Application for Works Approval

Works Approval Number W6317/2019/1

Applicant Water Corporation

Premises Waroona Wastewater Treatment Plant
22 Drake Road Waroona WA 6215

Figure 10. Process flow schematic

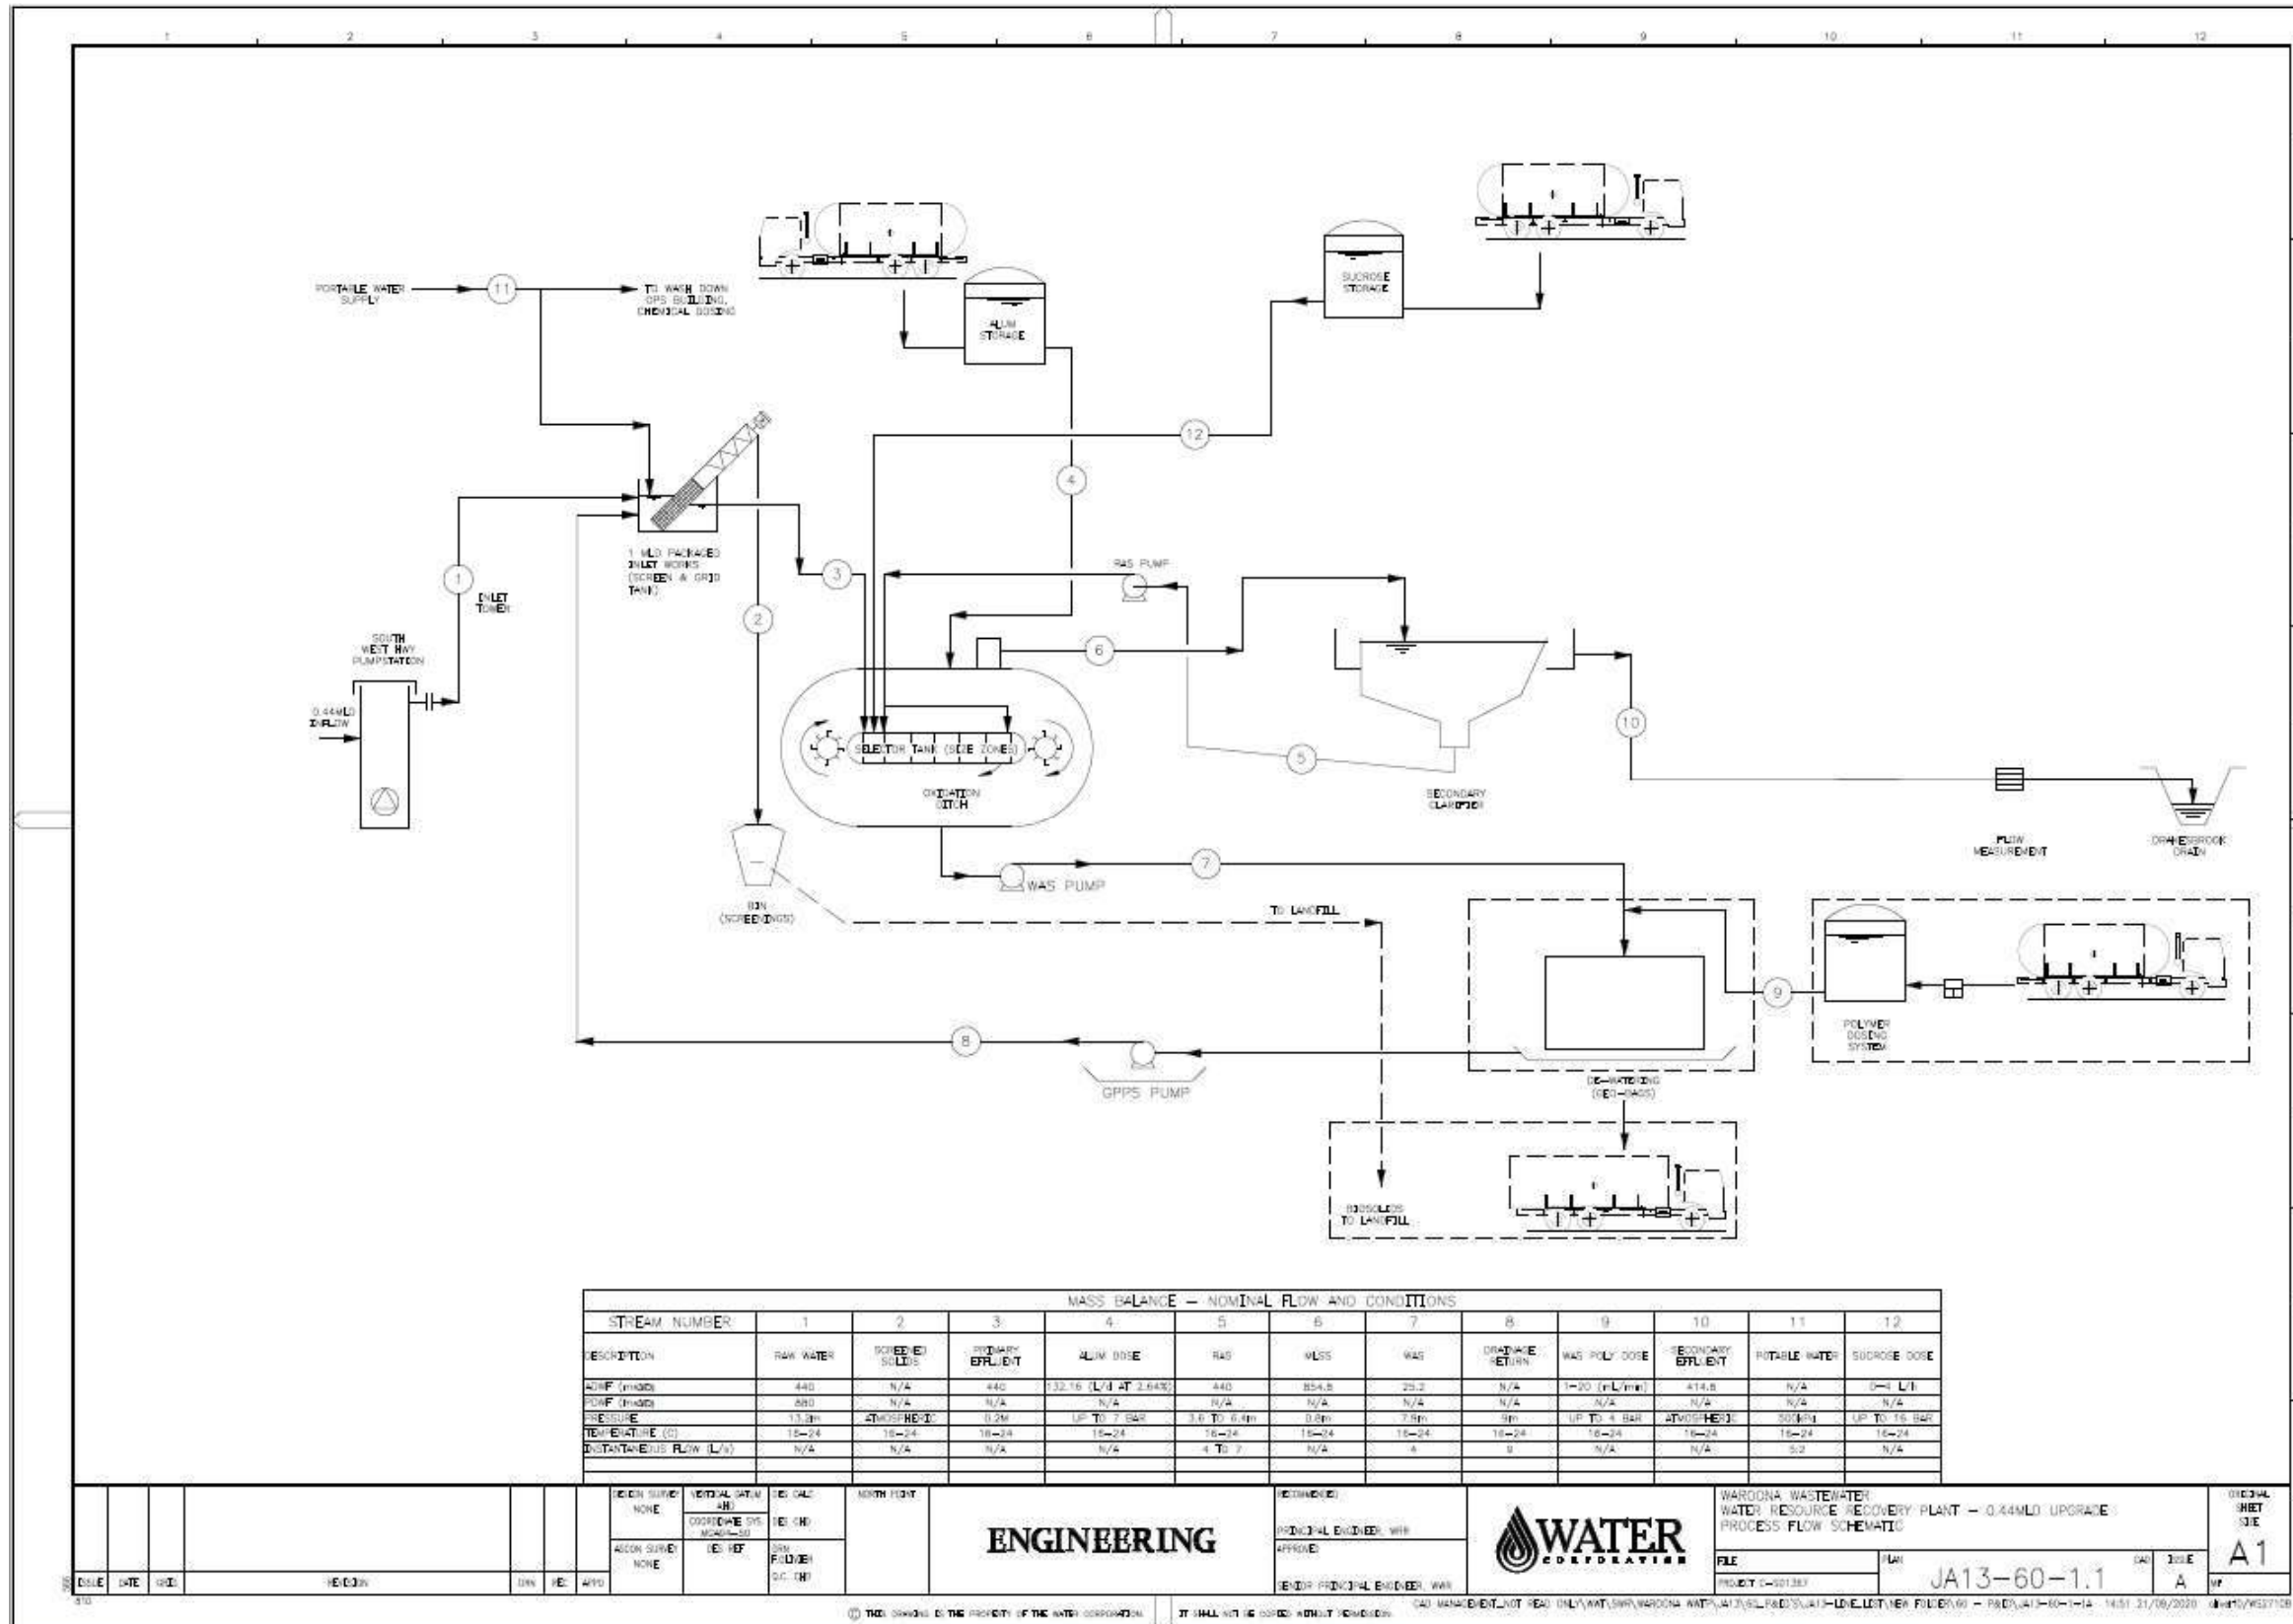
Pre-Treatment Inlet Works	Updated infrastructure details provided.	Phrasing has been amended.
Clay lined ponds	The existing clay lined ponds will be retained on site but disconnected from the treatment train and will not be used in an emergency.	Phrasing has been amended.
Appendix 3: Proposed Design Drawings	Update Figure 10 Process Flow Schematic as per attached figure.	Figure has been updated
